**INTERNATIONAL HYDROGRAPHIC ORGANIZATION**

*COLOUR & SYMBOL SPECIFICATIONS FOR ECDIS*

**C & S MAINTENANCE DOCUMENT**

**Number 1 – January 1999**

3. Re-number "Fig. 3-Usage of complex linestyle" as "Fig. 3a.-Usage of single unit type of complex linestyle", and add new "Fig 3b-Usage of composite type of complex linestyle" shown above

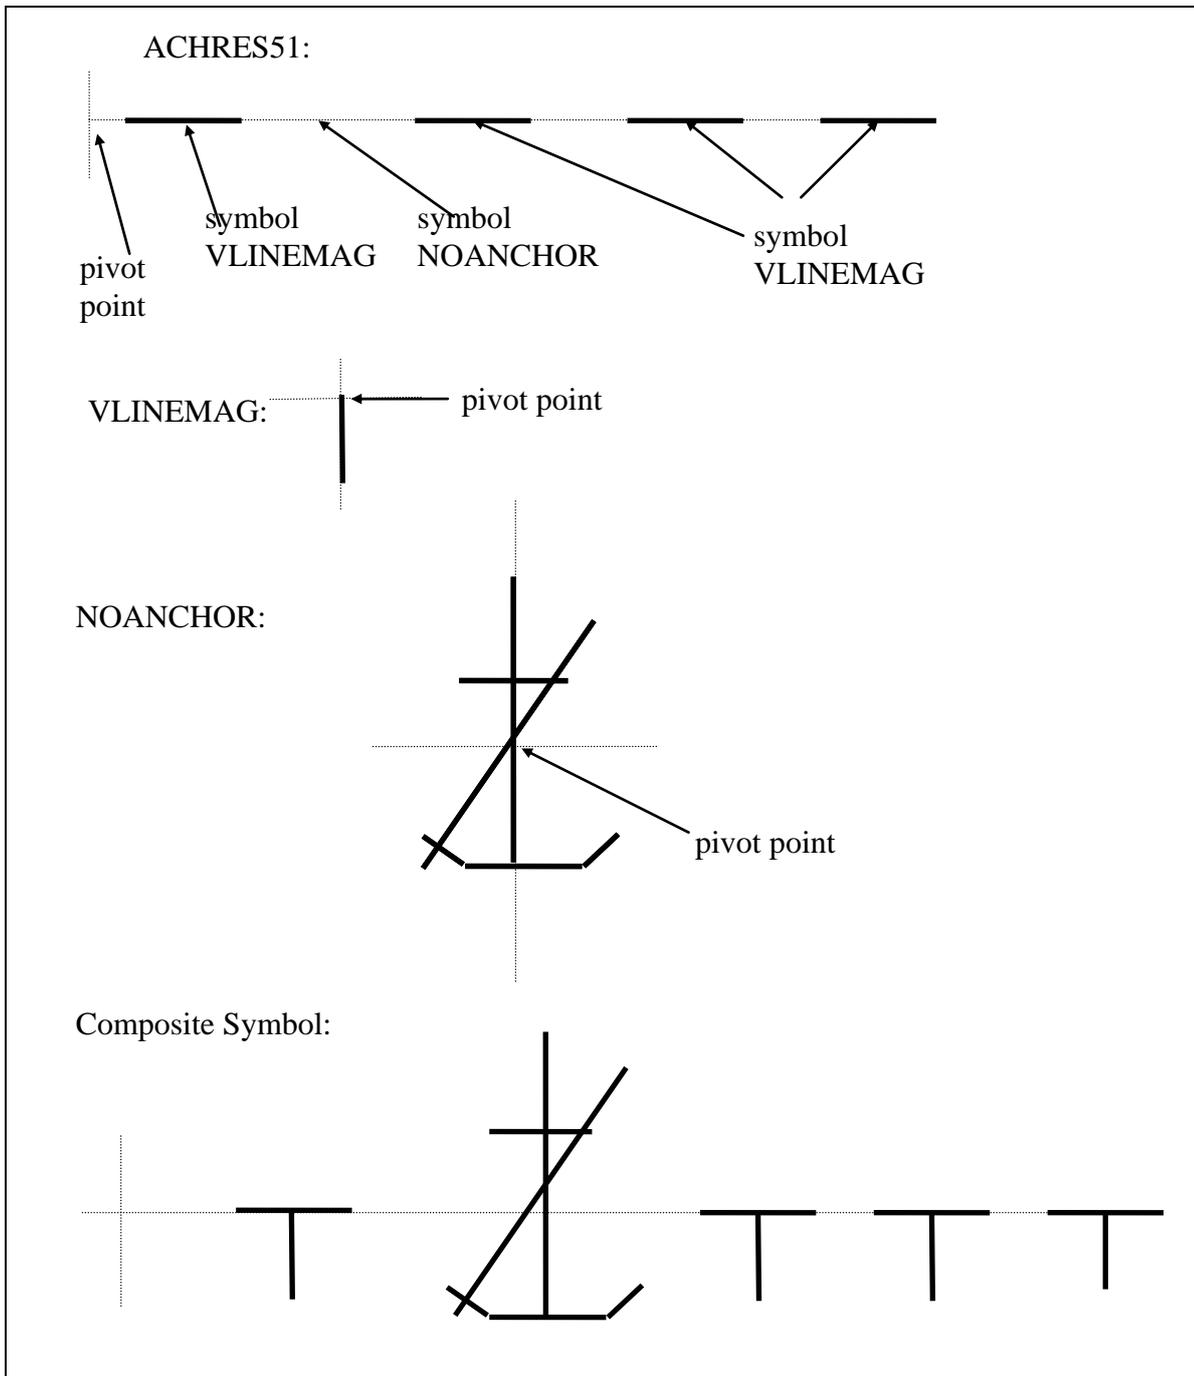
**The Presentation Library uses two types of complex linestyle symbol (see figures 3a and 3b):**

- (i) **The single unit type of complex linestyle is one in which the linestyle unit is described as a whole and is fitted as a string of units between the two vertices of the entire line object, using one orientation (figure 3a).**
- (ii) **However the single unit type of complex linestyle will only symbolize a straight line. To symbolize all lines, straight or curved, a composite type of complex linestyle is used, in which the unit is composed of a series of horizontal lines and symbols, strung together along the line object to form the linestyle unit, using a continually changing orientation if the line object is a curve (figure 3b).**

**5.2.2 For the single unit type of complex linestyle**, the orientation is given by the direction between two vertices of the line object that will be presented on the ECDIS display. The linestyle symbol is placed with its pivot point on the geometry of the line. The pivot point of the following symbol is placed where the run length of the preceding symbol ends. The run length is calculated by

**5.2.3 For the composite type of complex linestyle, locate the start and end position of each horizontal line in the complex linestyle along the edge to be symbolized. Then draw the complex line along the edge between the start and end positions. If a symbol needs to be drawn, then determine the angle of rotation by calculating the tangent of the edge at the location where the symbol is to be drawn. The symbol will then be rotated 90 degrees to the tangent. Figure 3b shows how the composite symbol is created from the linestyle and the embedded symbols. "**
